Ajax Project Review - Review of Predicted Water Contamination

Sierra Club of BC Foundation
301 - 2994 Douglas Street,
Victoria, British Columbia V8T 4N4

Kevin A. Morin, Ph.D., P.Geo., L.Hydrogeo.
Minesite Drainage Assessment Group
A Division of Morwijk Enterprises Ltd.
Surrey, British Columbia V3W 0R8
www.MDAG.com

March 26, 2016

Figure 4-1. A schematic comparison of typical testwork with humidity cells, columns, and in-field tests to typical full-scale reality in waste rock, tailings, and mine walls, showing that reality at Ajax can produce much higher concentrations than typical testwork.

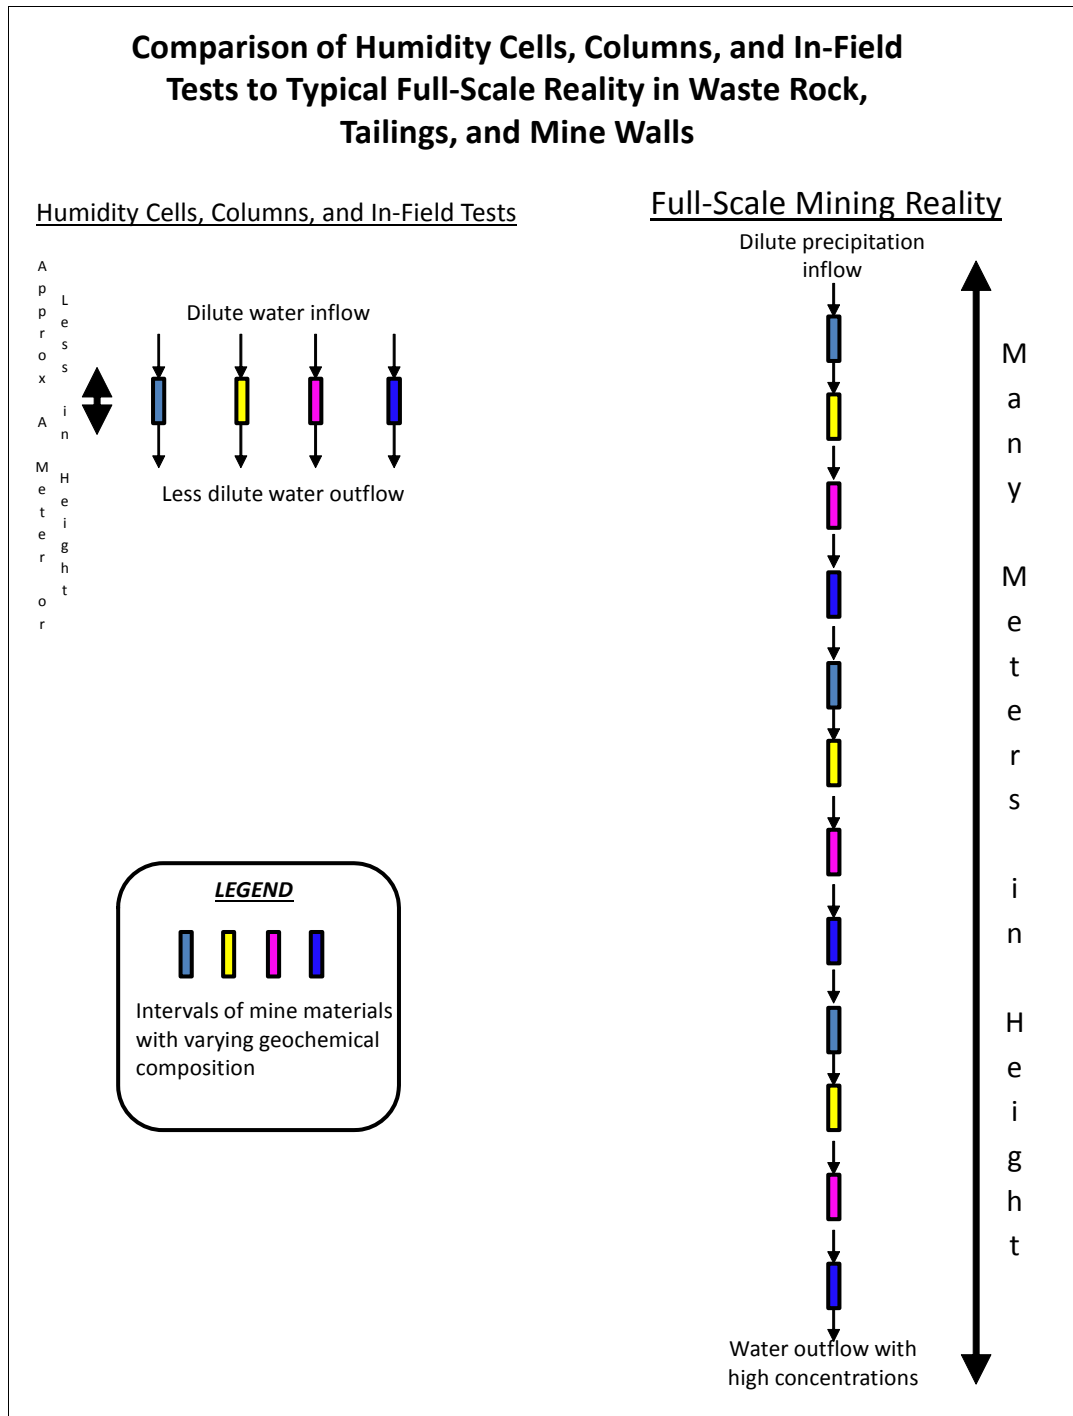
The testwork in Appendix 3-A put water through samples about 1 m in height or less (left side of Figure 4-1). At the proposed Ajax site, the waste-rock dumps would have heights of 85-270 m, and the waste-rock tailings embankments would be 10-122 m high (longer than the right side of Figure 4-1)! Would you expect concentrations in water that has passed through 100 m of rock to be higher than concentrations that passed through less than 1 m? I see they could be much, much higher.

As a result, the many comparisons of test results in Appendix 3-A to British Columbia water-quality guidelines are meaningless, because all we can surmise is that the real on-site source concentrations could be much higher and thus more contaminated to some unknown degree. Alarming, some concentrations from the short-length kinetic tests even surpassed provincial water-quality guidelines, so real on-site source contaminant concentrations could be highly toxic.

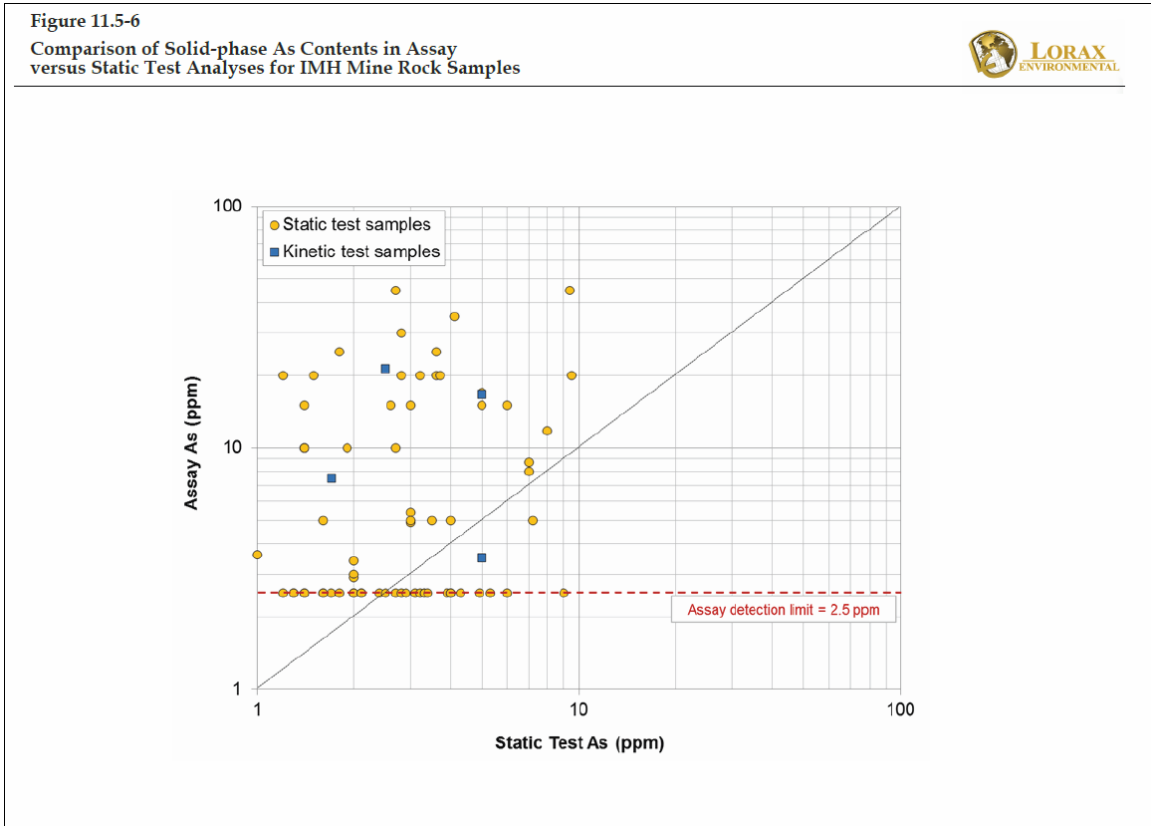
However, there is a telling clue to how extreme the differences are between the high assay values and the low the environmental values. Section 11.5.3.7 explains that solid-phase arsenic can affect how much arsenic is released to water and thus how contaminated the water can become. Figure 11.5-6 (reproduced in this review for convenience as Figure 4-2) then shows that the real, assay values are often greater than 10 ppm and approach 50 ppm (along the y-axis). In remarkable contrast, the corresponding environmental “static test” samples (along the x-axis) do not exceed 10 ppm and are often less than 4 ppm. There can be a difference of a factor of 10 or more. Again, the EIS, its estimates of contamination, and estimated of risk to humans and the environment are all based on the low, partial digestion values. Thus, environmental effects and risks may be underestimated by a factor of 10 or more in the EIS!

This approach and its underestimation of effects and risks are not precautionary (see Section 1 of this review), may not lead to non-zero harm, and may not even be reasonable. Nevertheless, KAM refuses to release the assay database.

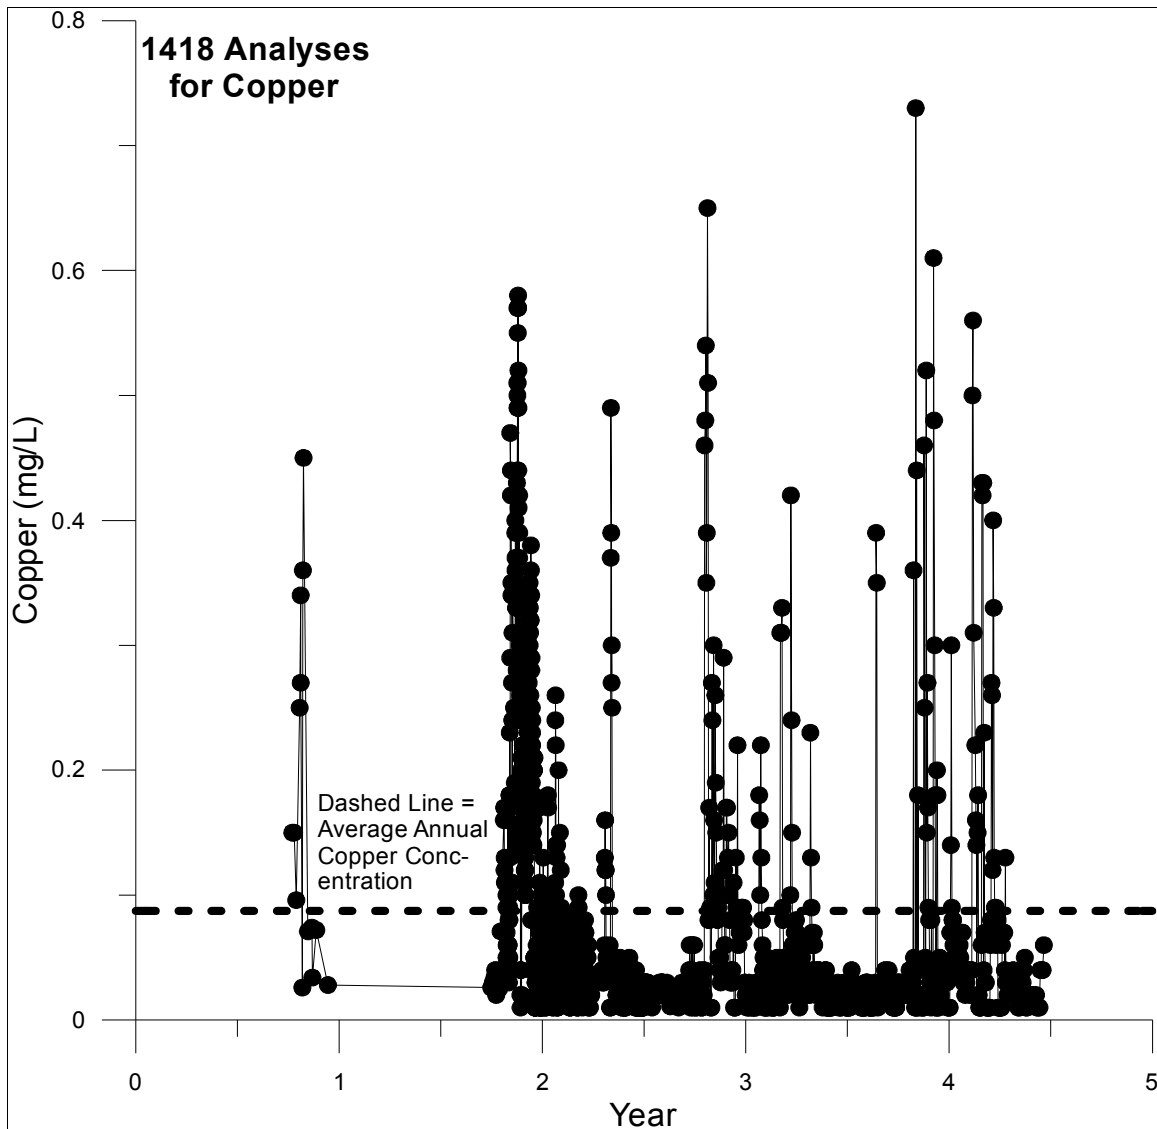
A simple illustration of this is in Figure 4-3 in this review. Figure 4-3 is based on real, full-scale near-neutral drainage, from waste rock, at a British Columbia copper minesite. In fact, this minesite is one of those in the special SRK database that Ajax chose for capping its maximum concentrations. This figure shows that the average annual concentration (0.0874 mg/L at the horizontal dashed line) can be exceeded for weeks or months each year, to levels that would be toxic to aquatic life. The horizontal dashed line in Figure 4-3 is how the Ajax EIS predicts high peaks in contaminant levels, whereas the solid, highly variable line shows reality with toxicity events.

For surface drainages into ditches and ponds, there might be some smoothing, but pulses of elevated contamination above average annual would still occur. In fact, Figure 4-3 shows real, full-scale pulses in a ditch draining waste rock. Perhaps if the ponds had retention times (holding all water entering them) for an entire year with no release, then the average annual might apply. However, this is not the plan for Ajax surface drainages and ponds according to the EIS.
